HISTORIC AND DESIGN REVIEW COMMISSION

March 06, 2019

HDRC CASE NO: 2019-064
ADDRESS: 307 E JOSEPHINE
LEGAL DESCRIPTION: NCB 1762 BLK LOT 25 (DPT SUBD UT-1) & NCB A-7 BLK LOT A-3
ZONING: I-1, RIO-2
CITY COUNCIL DIST.: 1
APPLICANT: Ray Soujoudi/DPT Labs
OWNER: DPT Laboratories, Inc.
TYPE OF WORK: Addition to an existing building
APPLICATION RECEIVED: February 08, 2019
60-DAY REVIEW: April 09, 2019
REQUEST:

The applicant is requesting a Certificate of Appropriateness for approval to construct a 2,869 square foot addition onto an existing prefabricated metal building.

4.2-01 SITE PLAN

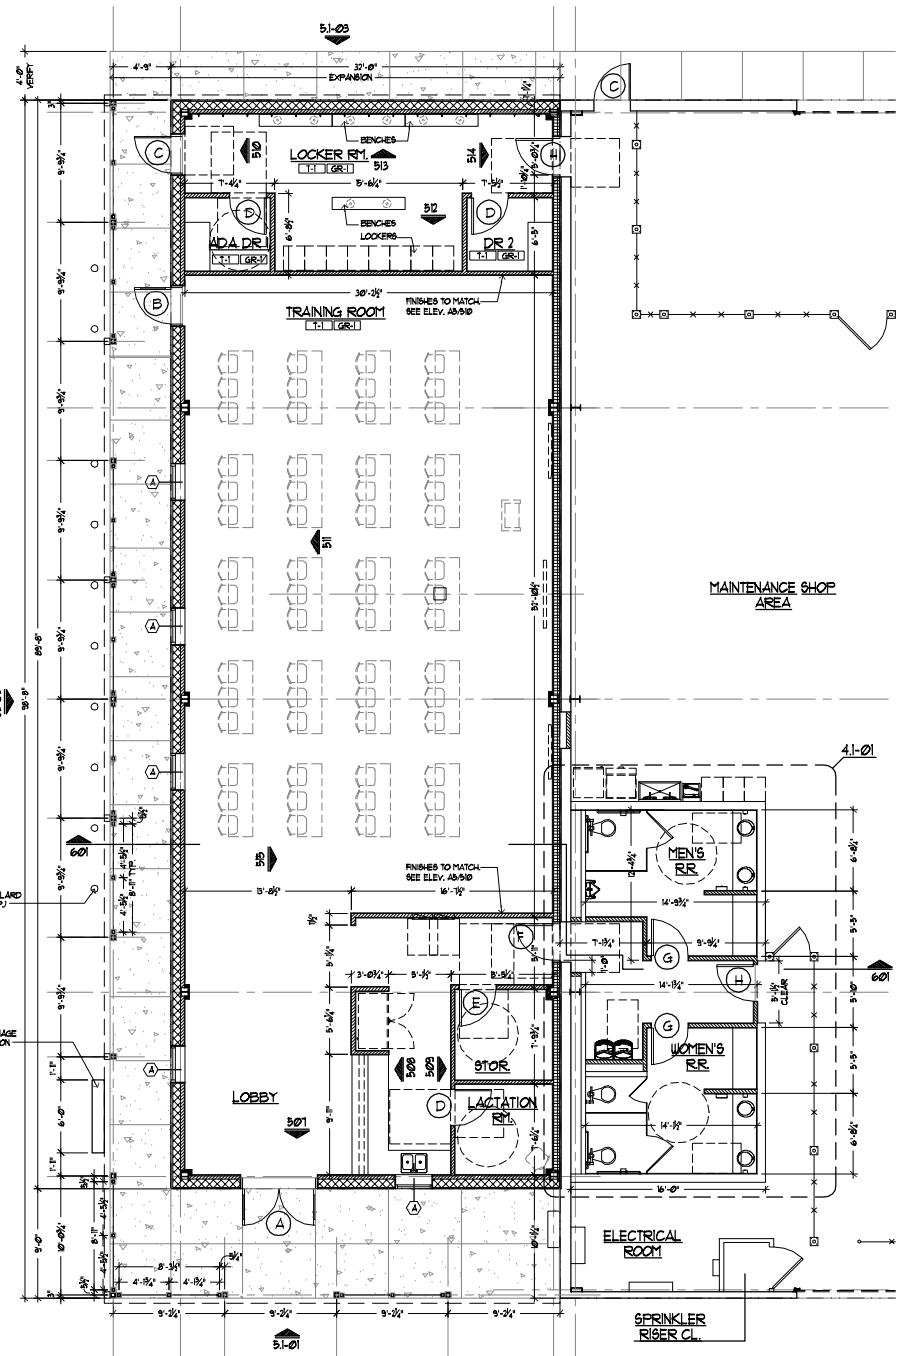
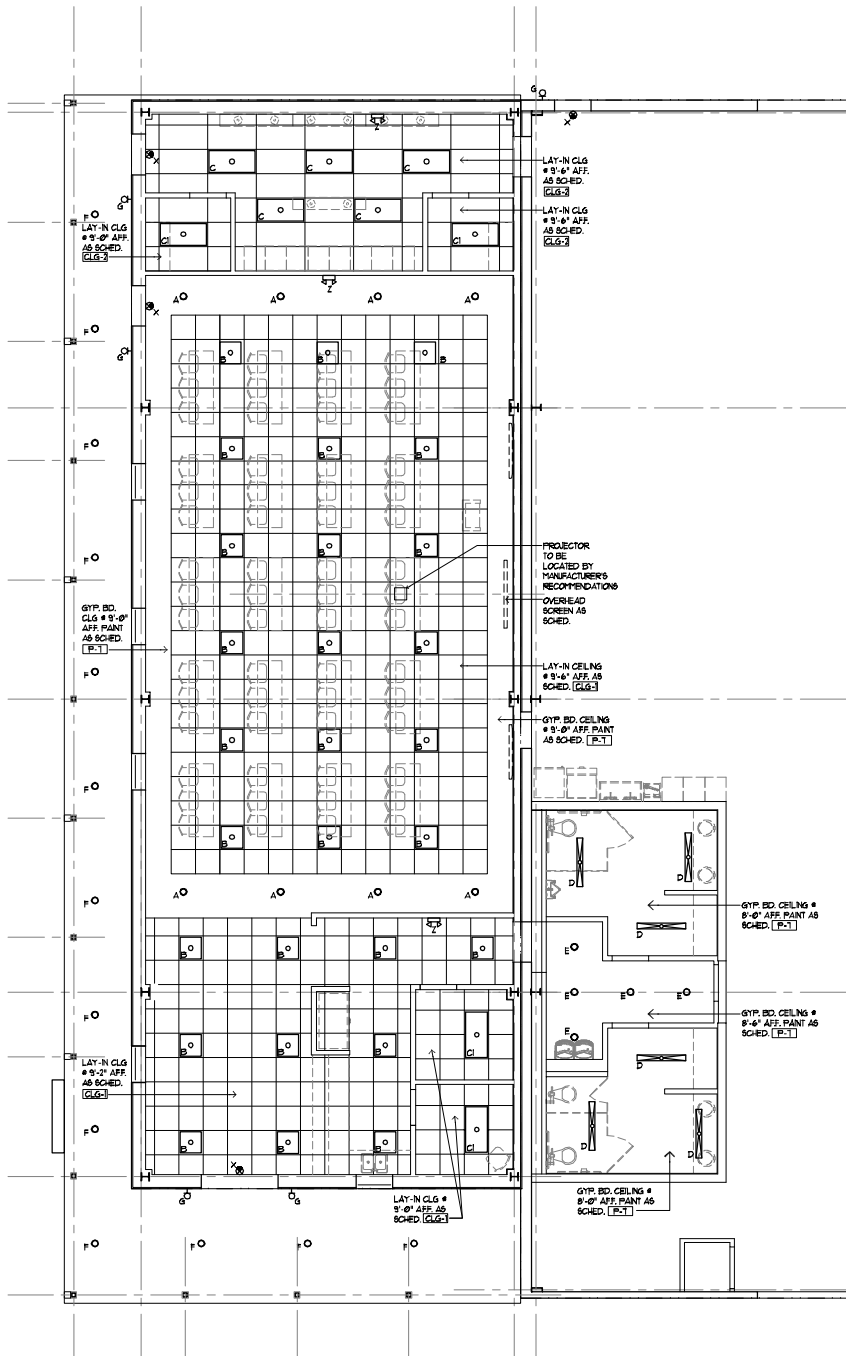
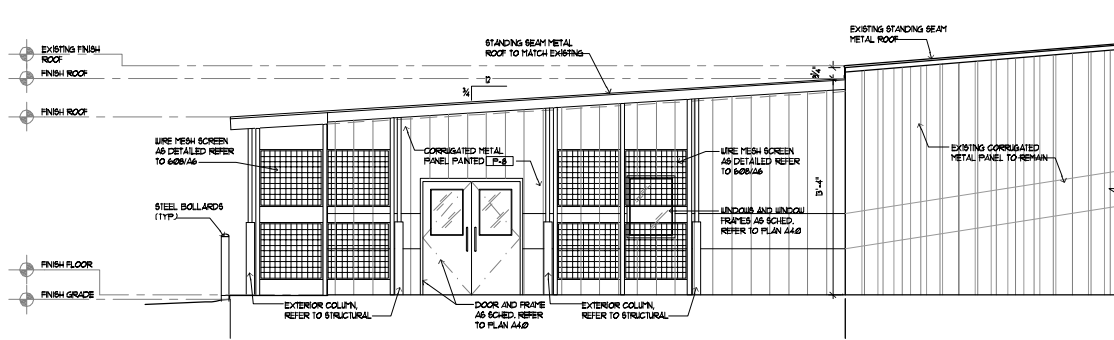
- b. ADDITION – The proposed addition will be constructed on the southern façade of an existing storage structure. The proposed addition will feature classroom space and will require modifications to the existing parking lot.

- c. LANDSCAPING AND PARKING BUFFERING – As noted in finding b, the existing parking lot will be modified to accommodate the proposed addition at the location of the addition. The Brackenridge Park Trail begins to the immediate west of this location. Staff finds that landscape buffering should be included to screen portions of the parking lot from the trail head to reduce the impact of the industrial nature of the site from the view of public property. The UDC requires all mechanical and service equipment to be screened from view at the public right of way.

5.1-01 EXTERIOR ELEVATION

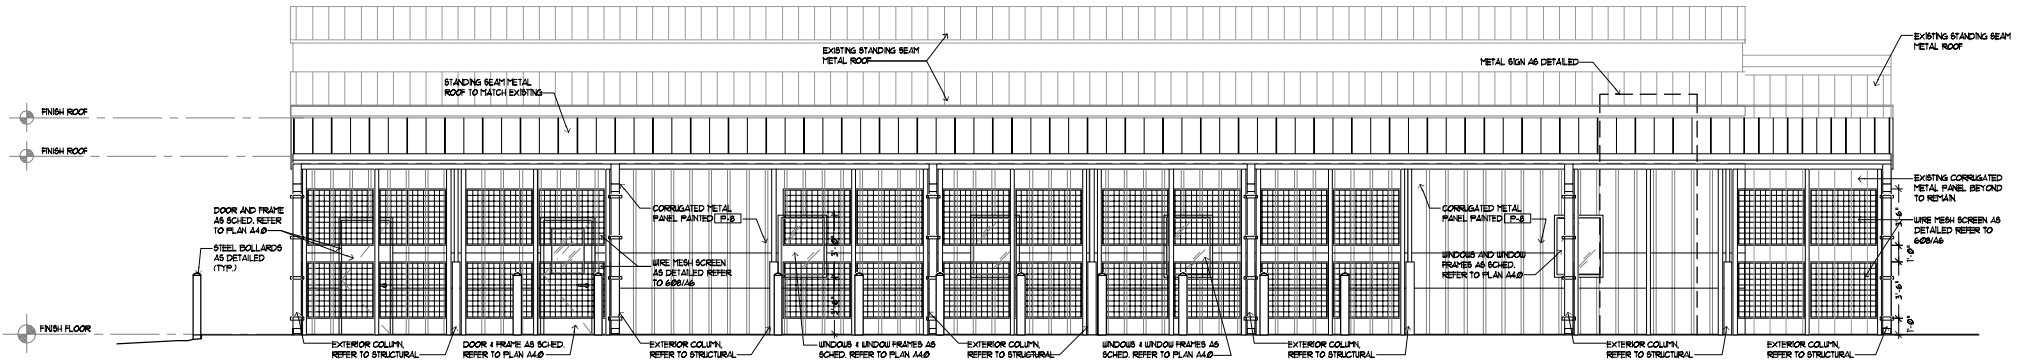
- i. That the proposed metal siding feature a flat finish and that all windows be recessed at least two inches within walls.
